Montgomery County Historic Preservation

Staff Report

<p>ADDRESS: 7818 Overhill Rd., Bethesda</p> <p>RESOURCE: Greenwich Forest Historic District</p> <p>APPLICANT: Bill and Allison Trunk</p> <p>REVIEW: HAWP</p> <p>CASE NO.: 1155067</p> <p>PROPOSAL: Accessory Structure Alterations</p>	<p>MEETING DATE: 5/13/2026</p> <p>REPORT DATE: 5/6/2026</p> <p>PUBLIC NOTICE: 4/29/2026</p> <p>TAX CREDIT ELIGIBLE: No</p> <p>STAFF: Dan Bruechert</p>
--	---

TRUNK GARAGE RENOVATION

DEMOLITION PLANS & ELEVATIONS
D100

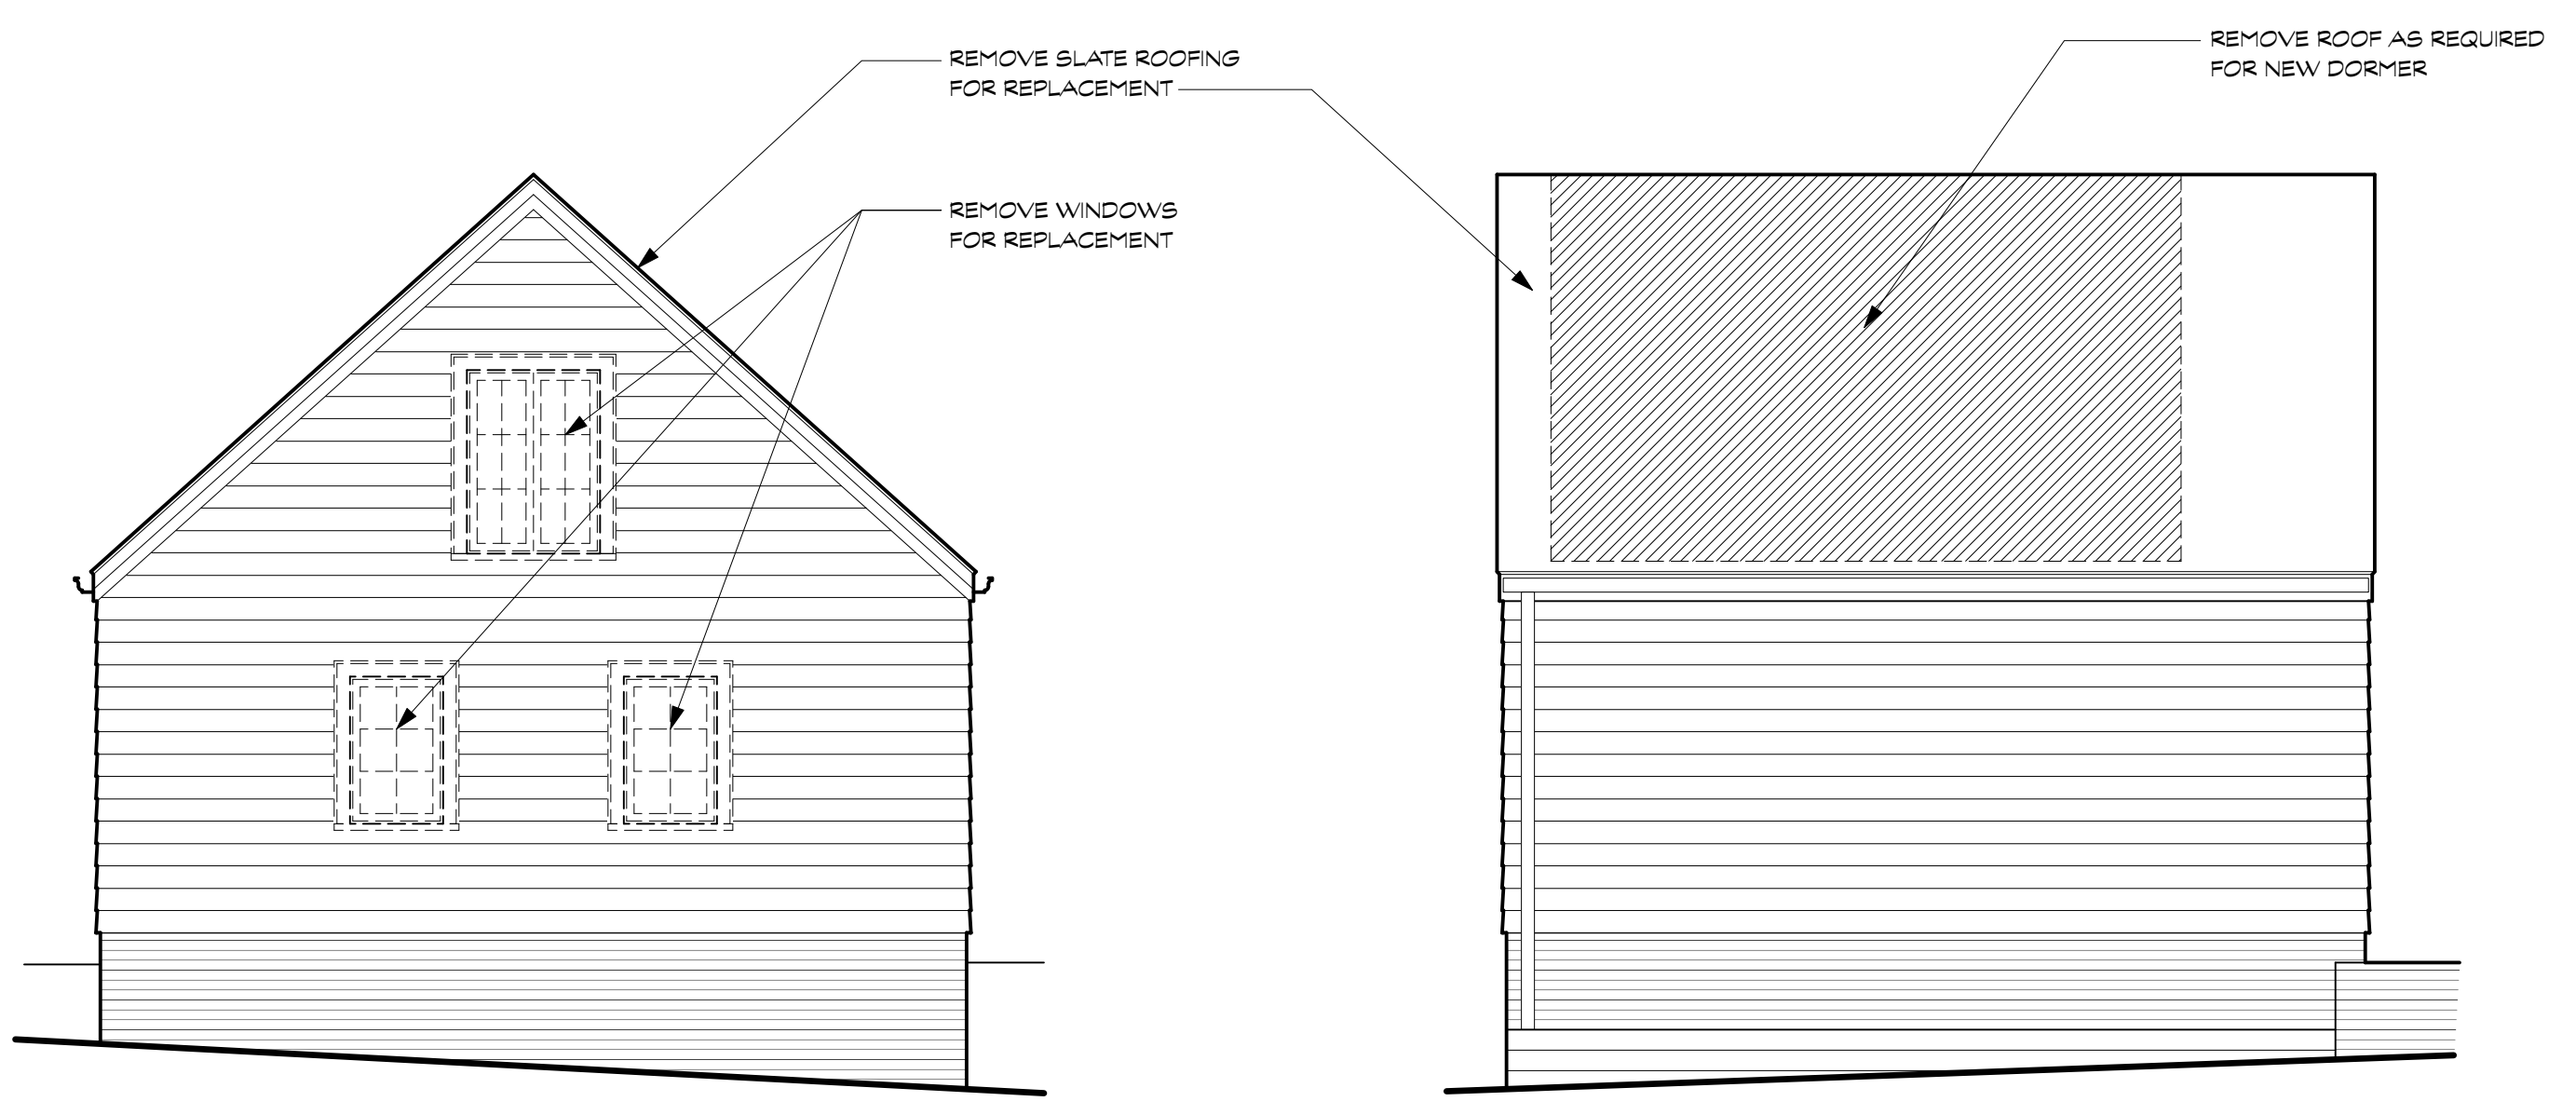
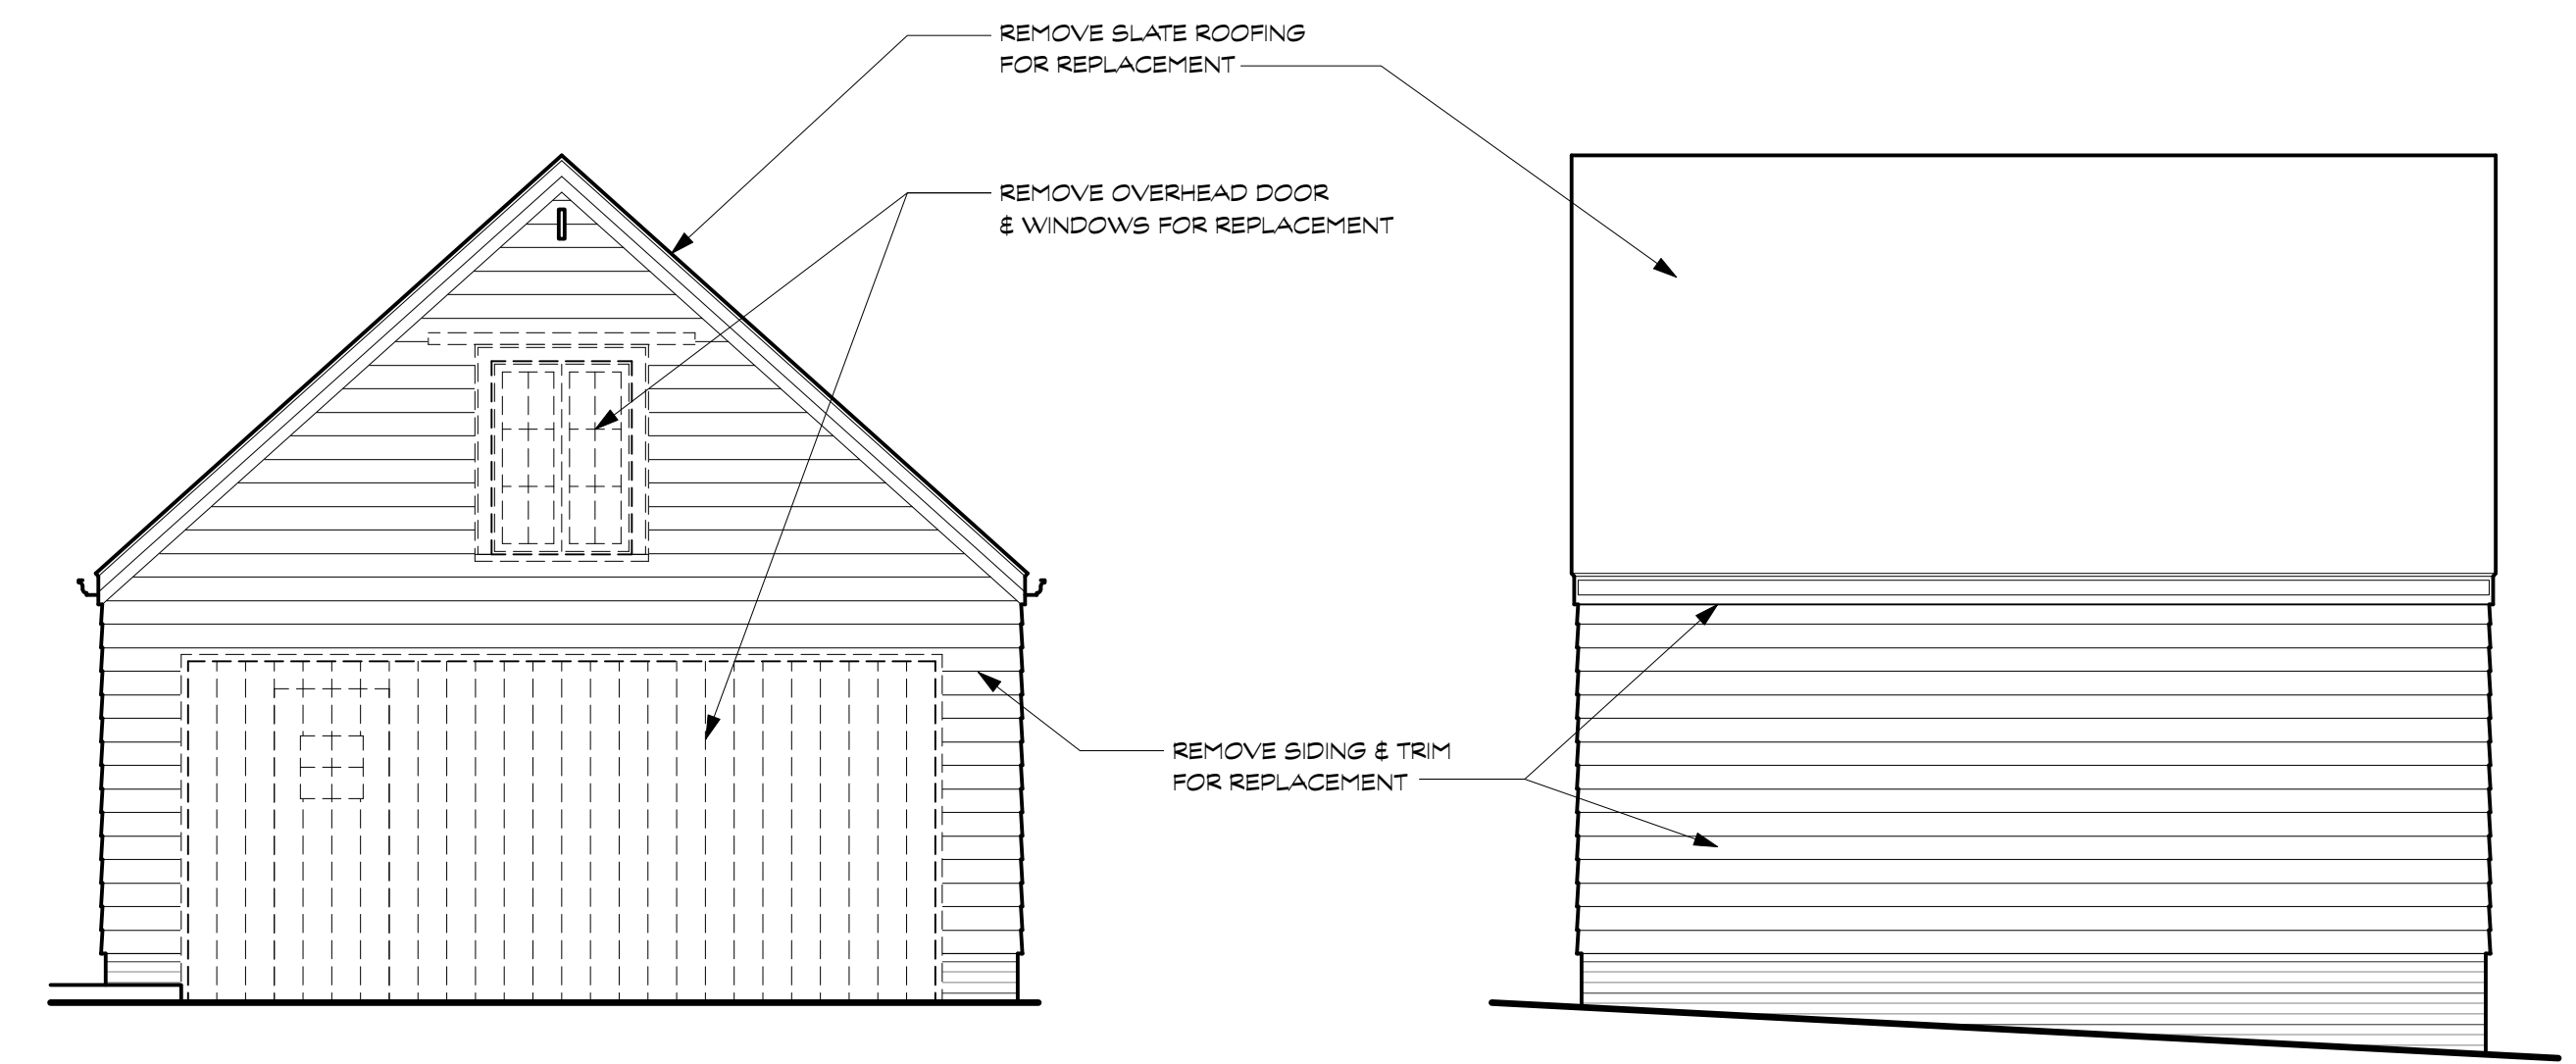
The existing garage has wood clapboard siding and a slate roof and is constructed on a brick foundation. There are pairs of wood casement windows under the front and rear gables and two fixed six-lite windows on the rear elevation. The wood overhead door includes a swing door with four-lites for pedestrian access. The existing wood siding and doors show signs of warping and some areas of rot.

The existing slate roof is identified by the applicant as being in “poor” condition. Staff’s observations at a site visit, which only examined the exterior, identified several broken slates. The applicant proposes to remove the existing roof and install an EcoStar synthetic slate roof in its place.

The existing overhead garage door is made of wood and has a swing door cut into the opening. The applicant proposes to remove this door and replace it with a partial width overhead door and a new swing door. A material specification was not provided for the new swing door, but the submitted building plans show it will be only 12' (twelve feet) wide, and the new swing door will be 3' 4" (three feet, four inches) wide. The proposed swing door looks like a vertical board door and has a foam core with a fiberglass exterior with an appearance that mimics stained mahogany.
